## Mobile Workshop Route Assessment Notes

Monday May 5<sup>th</sup>, 2014.

Queenston, Niagara to Stoney Creek, Hamilton

### St Catharines

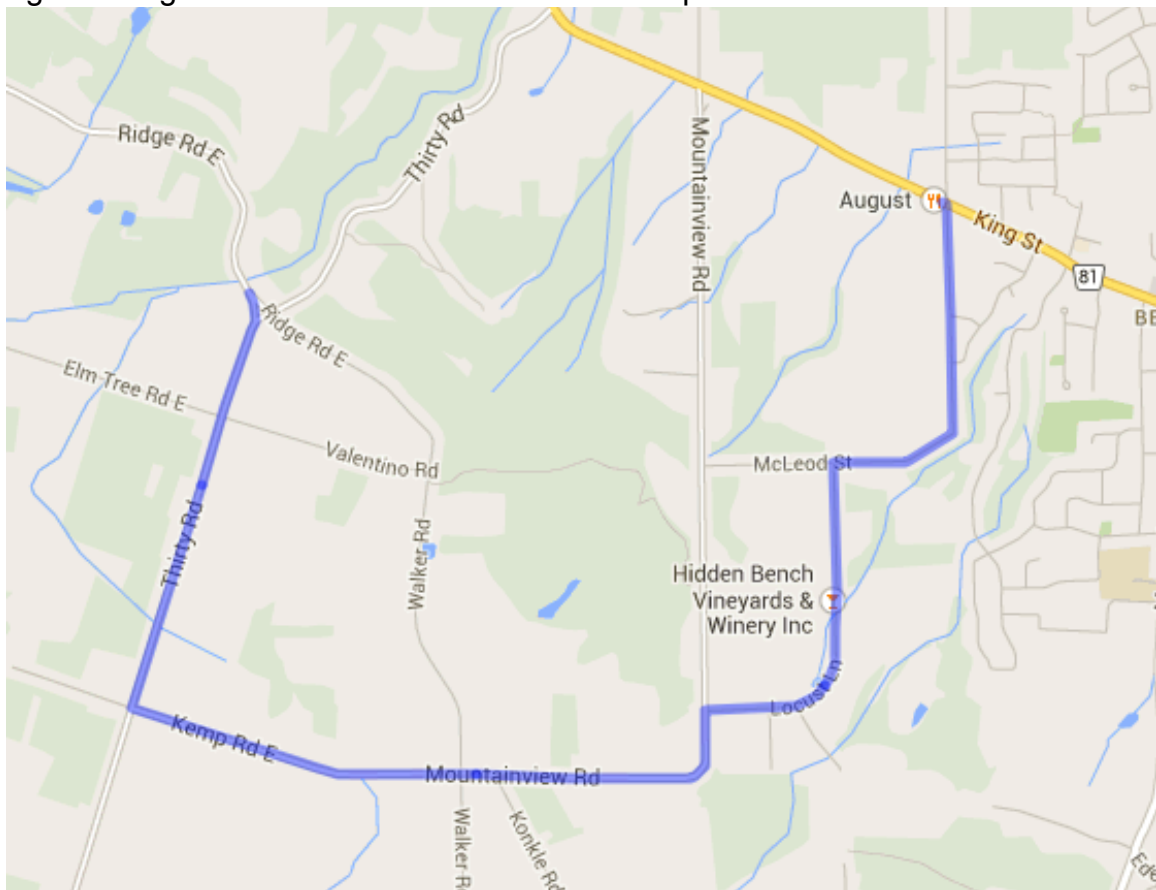
- tricky section on one way streets – good signage needed
- Condition of bridge over four mile creek will be variable for next few years – was closed to cars during mobile workshop
